Some updated design approaches we plan to implement in our version of TMS320F28379D MCU with its original code( scaled to accommodate 5V/80 amp case from , 380V from a PFC)

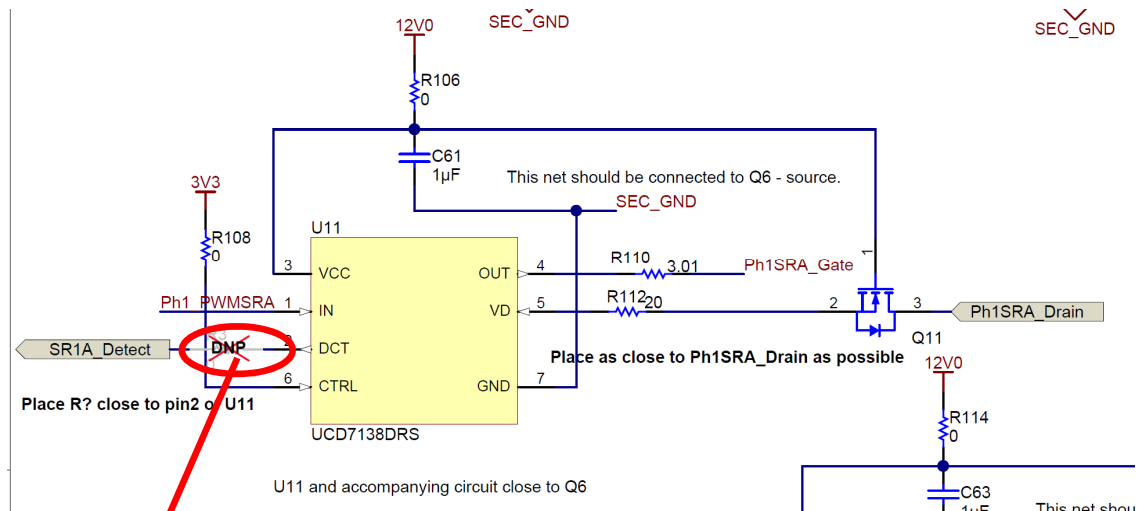
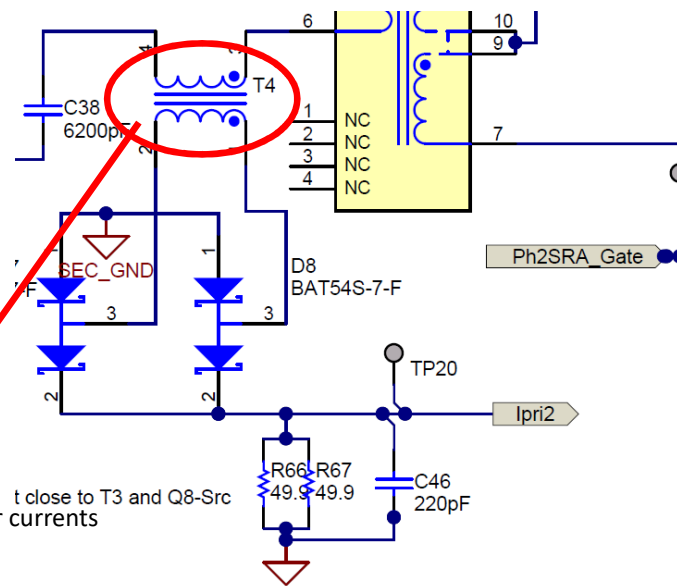
Does DNP mean the DCT outputs of UCD7138 are not connected to the processor?  
 What is then "R?" an open? How does processor give out correct SR timing for 8 such sync rectifier timing without DTC?

Can the current xmfr be smaller with known vt capability, can detect similar currents  
 Such as TDK B82801B?

.5mOhm /3.2W current sensing

non-dissipative current sensing  
NVE AAL0024-10E sensor

Figure 11. Constant-current supply.

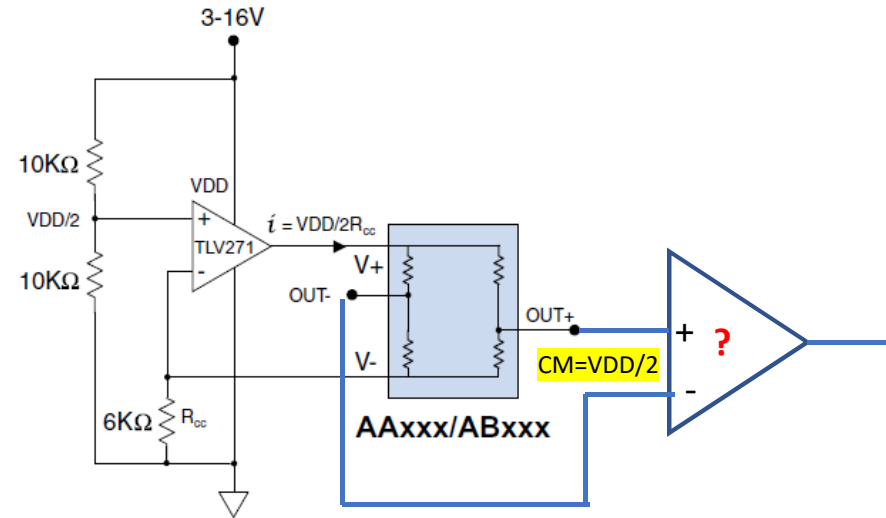
WITH VDD =12V, LOOKING FOR A DIFF OPAMP  
SAME FILTERING WILL BE ADDED

## NAV6117 BASED APP

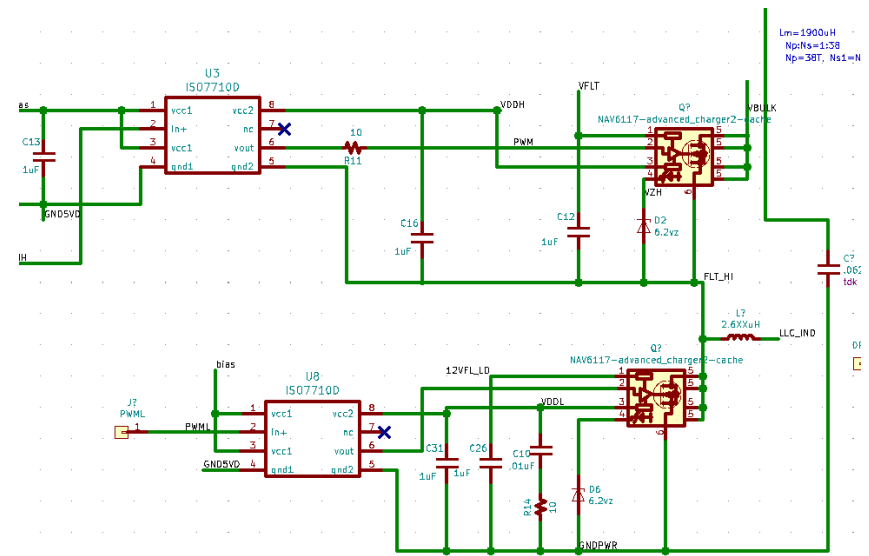
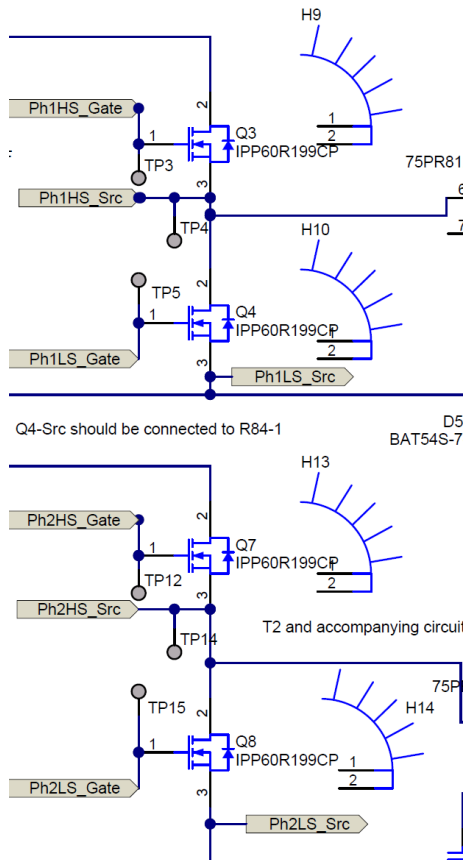
Do you see any issues if we use the same code ?

### MOSFET BASED SR

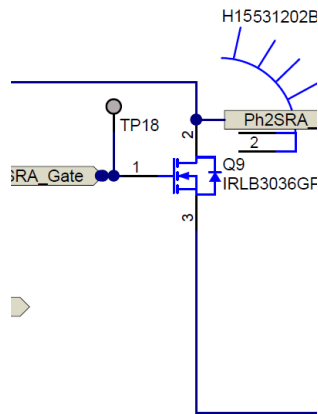
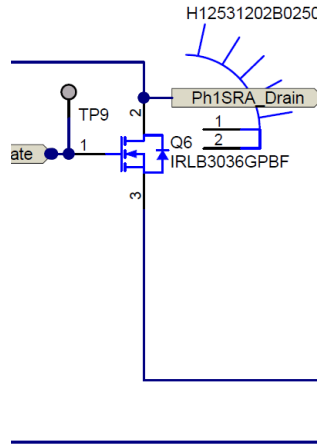
Do you see any issues if we use the same code ?
